Randwick Local Planning Panel (Public) Meeting

Development Application Report No. D58/24

Subject: 3-7 Bona Vista Avenue, Maroubra (DA/811/2023)

Proposal:	Demolition of existing buildings and construction of 2-storey dwelling house with new in-ground swimming pool, central courtyard, retaining walls, and landscaping works.
Ward:	Central Ward
Applicant:	Mr A Delloye
Owner:	Game On Maroubra Holdings Pty Ltd
Cost of works:	\$6,438,619.00
Reason for referral:	Greater than 10 unique submissions by way of objection were received.

Figure 2: Amended Proposal at Subject Site after Council's RFI – West Elevation (appearance from the street) (Source: Dominic Levene)

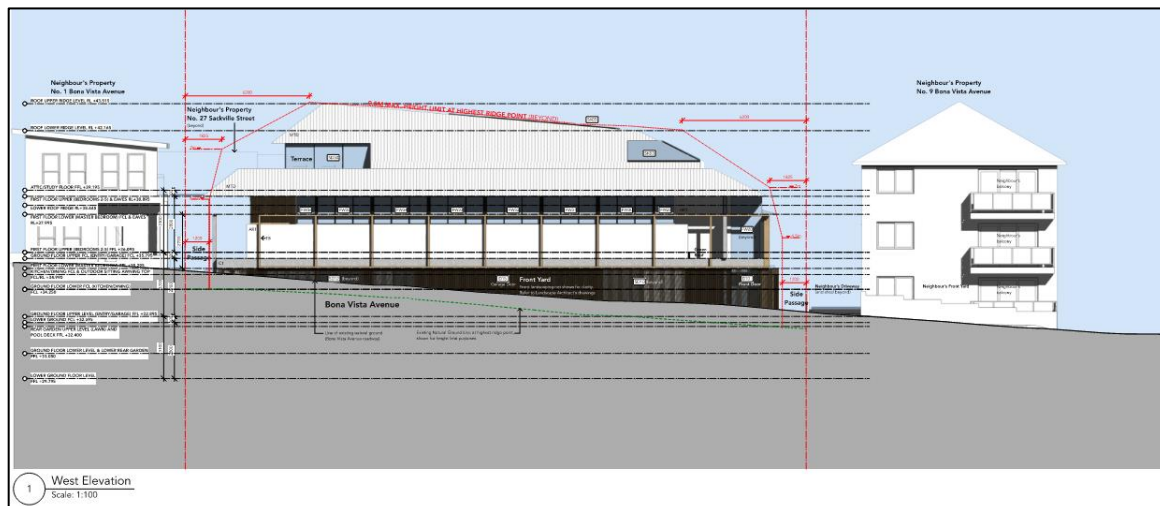
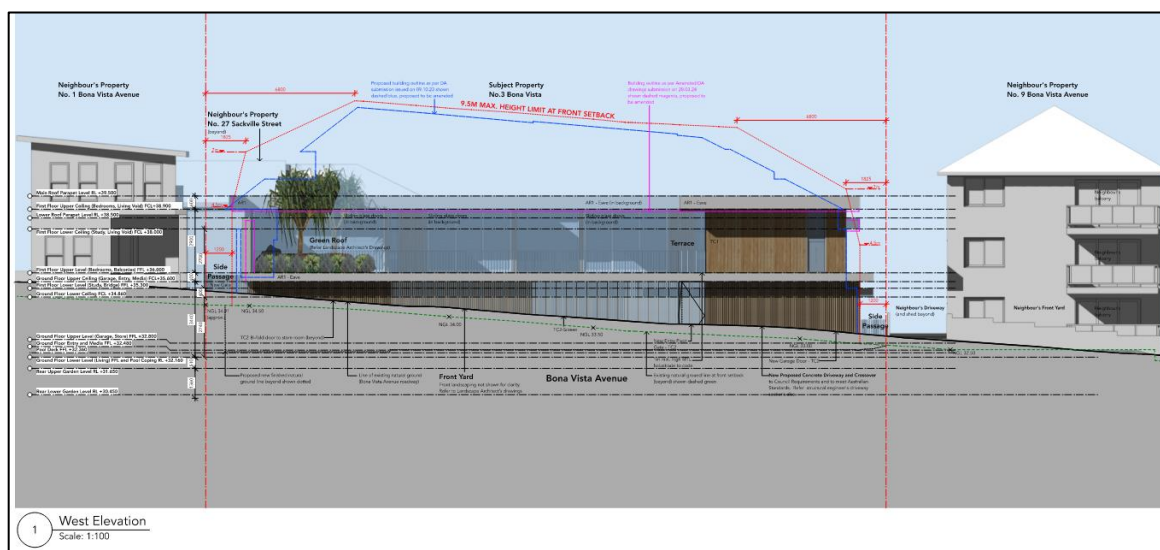
The original proposal was lodged with Council on 11 October 2023. A Request for Further Information was issued on 15 February 2024, raising numerous concerns with the proposal and stating that the proposal was not supported its original form. Amended Plans were received by Council on 31 March 2024, resulting in a significantly modified proposal.

*The original proposal is also shown in blue outline in **Figure 2**.

Figure 4: Amended Proposal at subject site after Councils RFI - East Elevation (appearance from the rear) (Source: Dominic Levene)

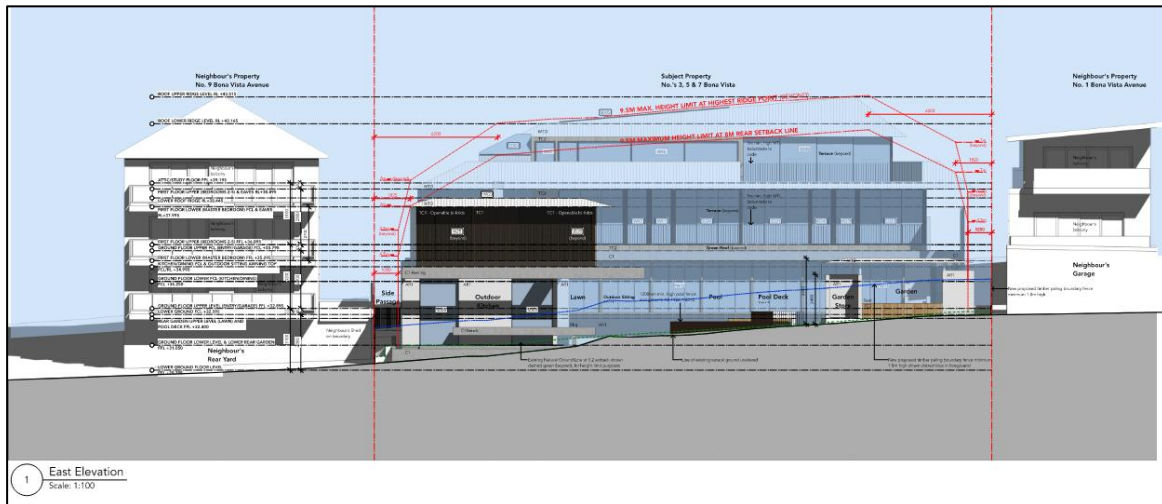
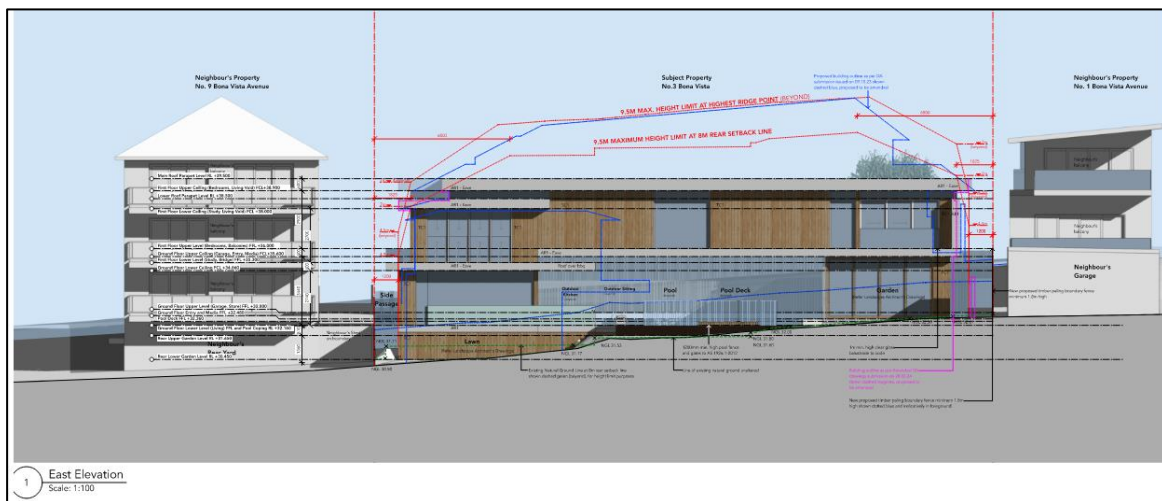
*The original proposal is also shown in blue outline in Figure 4.

Figure 25: Amended proposal

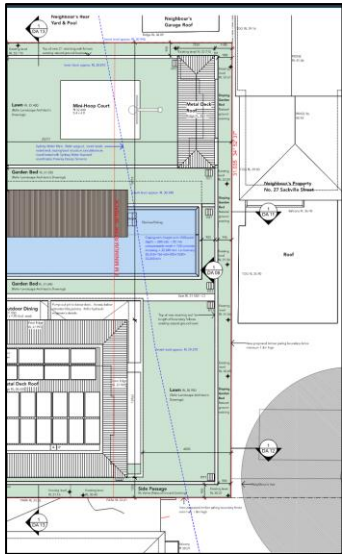
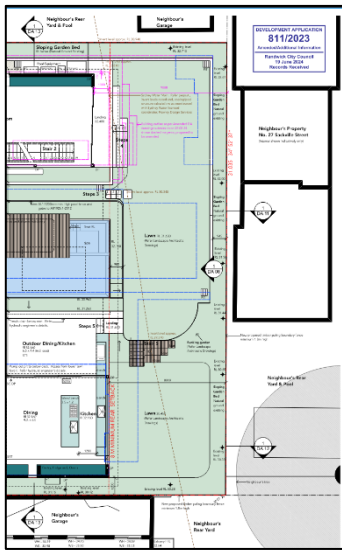
The rear garden of the amended proposal is now largely free of structures within this 8m rear setback, when compared to the original proposal (see below).

Figure 52: Southern (side) Elevation at 3 - 7 Bona Vista Avenue.

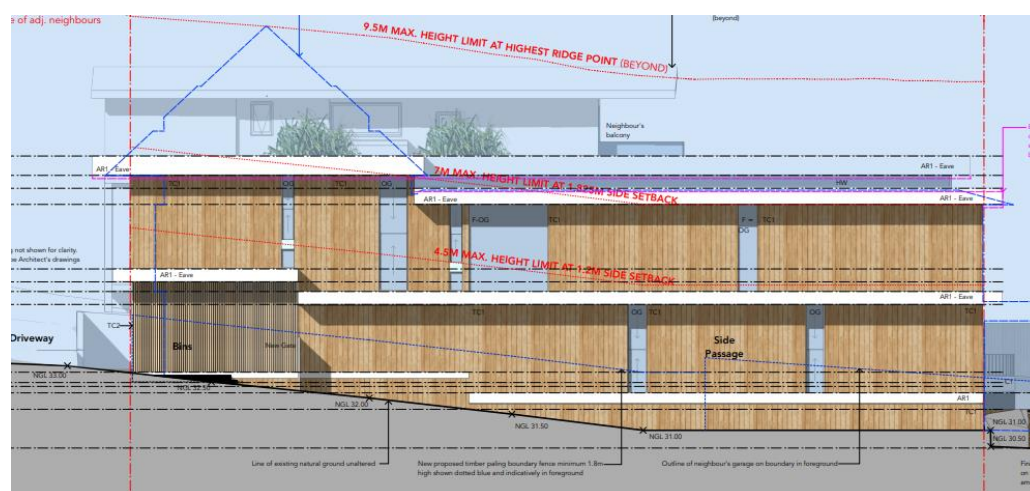
The Southern (Side) Elevation is appropriate because it involves changes in levels, the first floor is set in from the ground floor and it has an interface with a residential flat building in the R3 Zone, which has a long side elevation.

Figure 56: Southern Elevation of proposal.

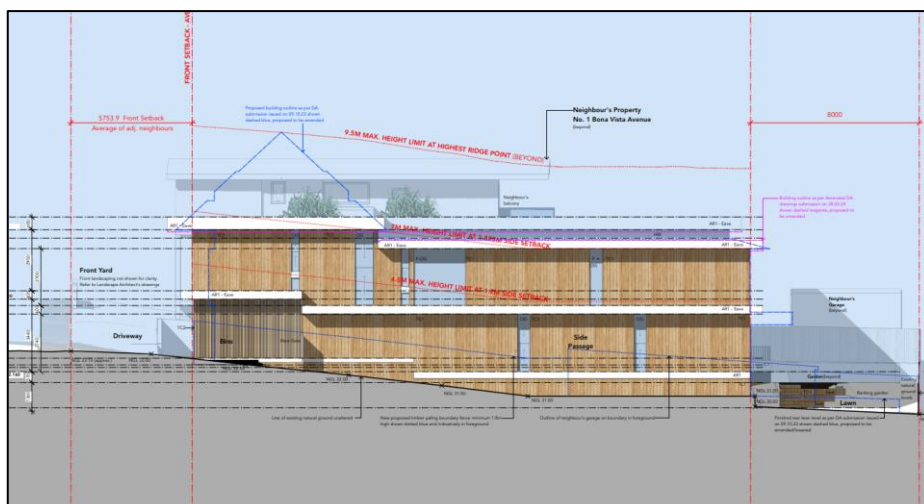
As shown in the figure below, the southern facing windows have been reasonably reduced. These consist of obscured/opaque glazing and a condition has been included to ensure that the windows are obscured to a minimum of 1.6m above the finished floor level.

At ground level, the windows have been limited to two narrow openings. On the first floor the largest opening is to a stair void and other smaller windows are to bedrooms, an ensuite or a void.

Figure 58: First floor plan - 3-7 Bona Vista Avenue

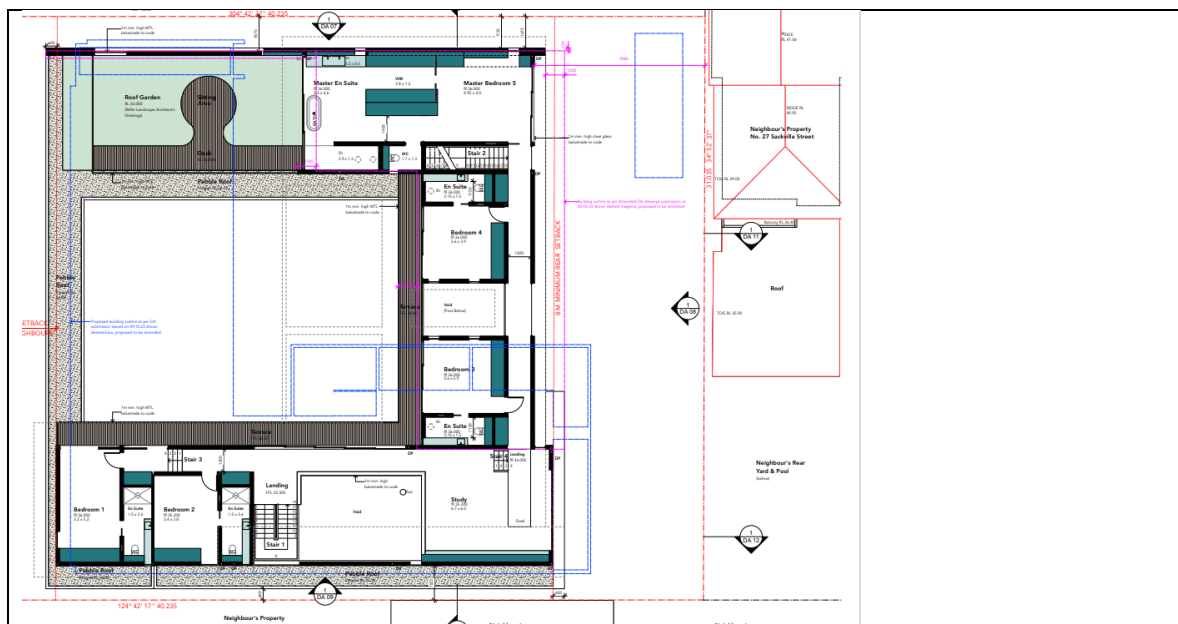
The Master bedroom (5) faces the blank western elevation of 27 Sackville Street, which is also obscured by vegetation. Shown in the Figure below. This room/ view does not pose visual privacy impacts on 27 Sackville Street.

The study located on the southern side of the first floor and has large opening facing toward the east and 27 Sackville Street. Because the study is elevated and the land drops down to 27 Sackville, there will be views into the private open space of 27 Sackville Street.

DCP Clause	Controls	Proposal	Compliance
	<p>included for horizontal louvre screens, which are 30mm deep and have 30mm spacing. These will be to a height of 1.6m and must be angled to prevent overlooking of the POS of 27 Sackville Street.</p> <div data-bbox="212 351 933 598" data-label="Image"> </div> <p><i>Figure 60: 27 Sackville Street Pool and POS, view from 7 Bona Vista Avenue toward 27 Sackville Street</i></p> <p>There is significant planting proposed, improving the landscaped outlook and privacy for the adjoining site.</p> <p>Overall, this condition will manage overlooking of POS for 27 Sackville Street.</p>		
	Balcony		
	<ul style="list-style-type: none"> iii) Upper floor balconies to street or rear yard of the site (wrap around balcony to have a narrow width at side) iv) Minimise overlooking of POS via privacy screens (fixed, minimum of 1600mm high and achieve minimum of 70% opaqueness (glass, timber or metal slats and louvers) v) Supplementary privacy devices: Screen planting and planter boxes (Not sole privacy protection measure) vi) For sloping sites, step down any ground floor terraces and avoid large areas of elevated outdoor recreation space. 	Rear and side balconies are located and orientated so as not to cause adverse privacy impacts to neighbours.	Complies.

Figure 25: Proposed basement 1 floor plan with the communal open space shaded in blue - 18-20A Perouse Road, Randwick (Source: Curzon & Partners)

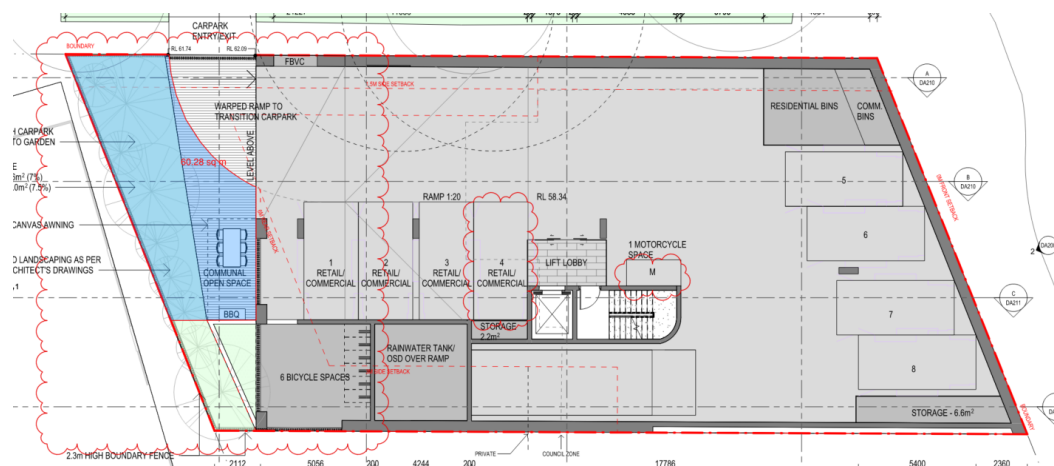
The proposed development has a designed for communal open space along the western side of the site, with an area of only 9.7% (or 60.2m²). This non-compliance represents a variation of 15.3% of the design criteria, which is a significant variation. See Figure 25 below.

It is noted that the proposed communal open space will receive 2hours of direct sunlight during the middle of the day, in accordance with the ADG.

Figure 26: Proposed basement 1 floor plan with the additional communal open space shaded in pink - 18-20A Perouse Road, Randwick (Source: Curzon & Partners)

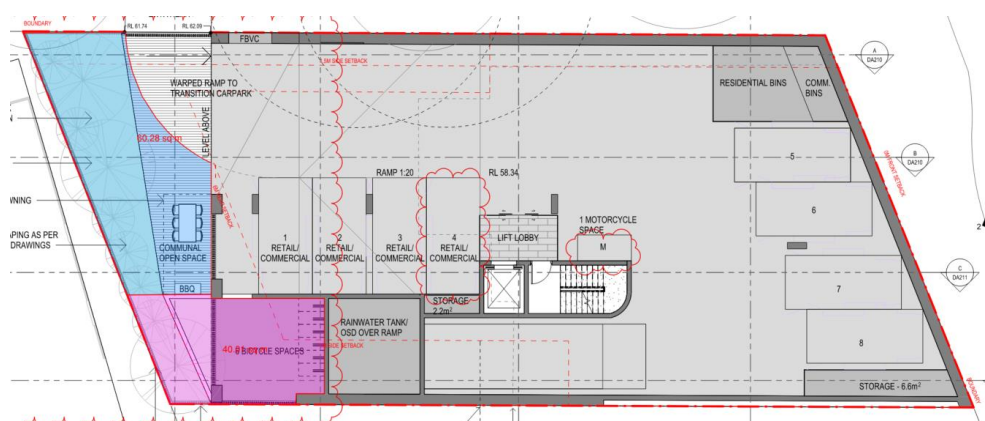
Subsequently, there are opportunities to increase the size of the communal open space without impacting upon the amenity of the site as well as the impacts on the western adjoining neighbours. The area to the south of the COS is made up of a raised planter box and a large area for bicycle parking (see highlighted in pink in Figure 26 below).

There is scope to relocate the bicycle parking spaces within the basement 1 level and delete the planter to convert this area into an additional area for COS for the building occupants. Whilst part of this area will be roofed and be enclosed with fencing along the boundary to 2.3m (500mm from a retaining wall and 1.8m for the boundary fence), the allocation of this area to more COS supports further areas for building occupants to gather and undertake social interactions.

Figure 27: Proposed southern elevation showing the DCP building height plane in blue - 18-20A Perouse Road, Randwick (Source: Curzon & Partners)

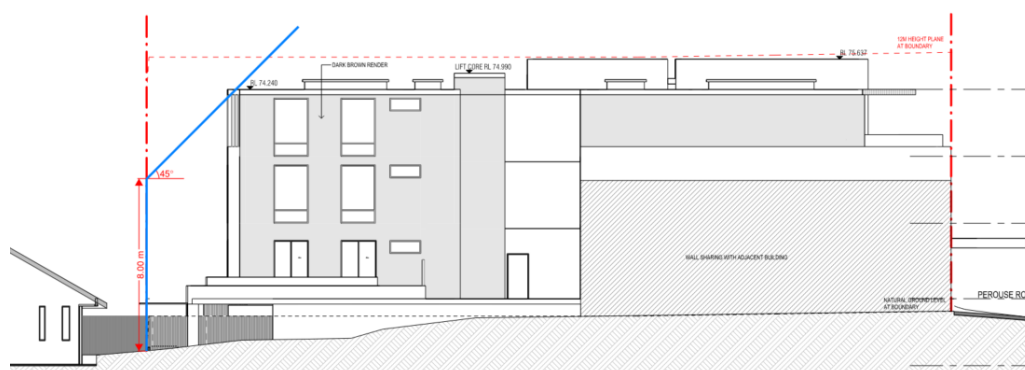
The proposed development is mostly contained within the building height plane, in accordance with the provision in this control. Figure 27 below shows that only a small portion of the building fails to comply with the building height plane.

Council notes that this section of non-compliance is only minor, as the setback to the western boundary to the proposed building varies between 5.12m to 9.32m. This accounts for the angled western boundary line to the site and the positioning of the building in proximity to it. See Figure 28 below to demonstrate the western setbacks at different points to the building.

Figure 30: Proposed Unit 1 balcony with Council measurements in red - 18-20A Perouse Road, Randwick
(Source: Curzon & Partners)

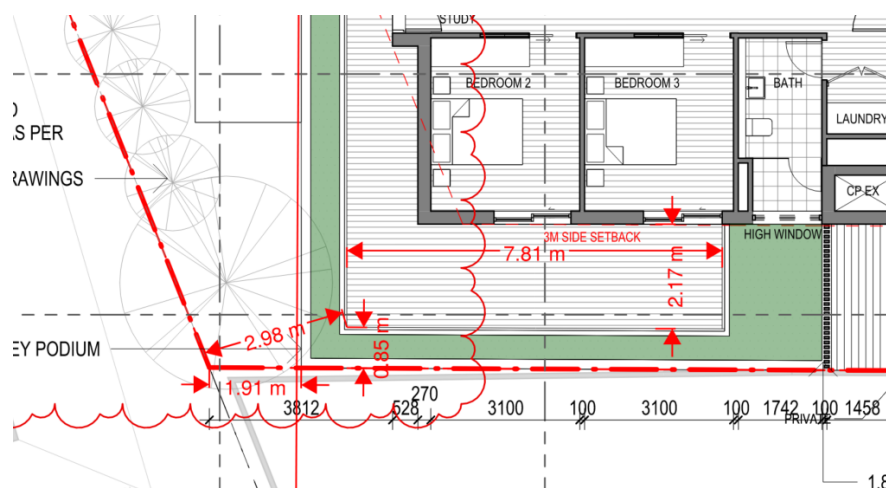
Council is satisfied that the balcony does not overlook the southern neighbour as the balcony is located adjoining a single commercial storey building, which prevents any overlooking. However, Council is concerned that the balcony will overlook the adjoining western neighbour's rear yard. Furthermore, Council is concerned that the 2.17m x 7.81m southern terrace is large enough to hold a number of occupants that will result in acoustic visual impacts on the western adjoining neighbour. See Figure 30 below.

Figure 31: Proposed level 1 floor plan showing the reduced balcony to Unit 1 with various markings - 18-20A Perouse Road, Randwick (Source: Curzon & Partners)

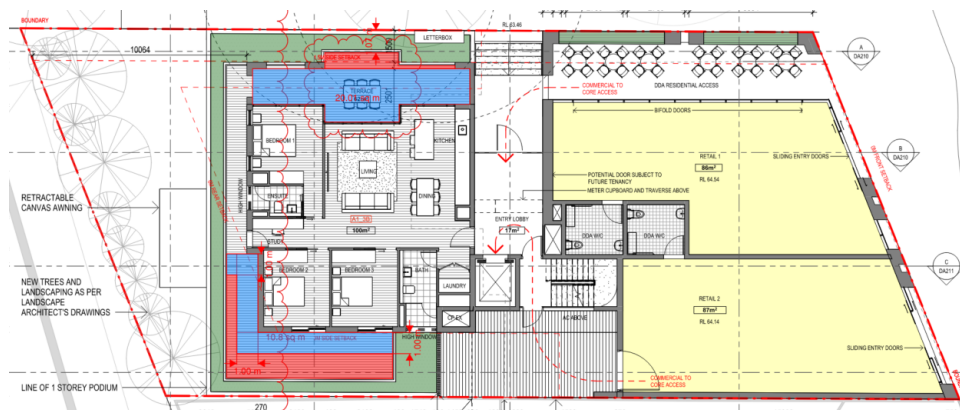
Council notes that a small section of the northern terrace is only setback 1.1m from the northern side boundary. Council does not support this small section protruding forward as it will impact upon the streetscape and built form of the building. A further condition has been recommended that front terrace section is to be setback 1.5m from the northern boundary, with the area to be integrated into an additional planter zone. The front terrace will retain 20m² in size (excluding the area of the terrace to the western and southern side of the unit layout. See Figure 31 below, with areas retained in blue and reduced in red.
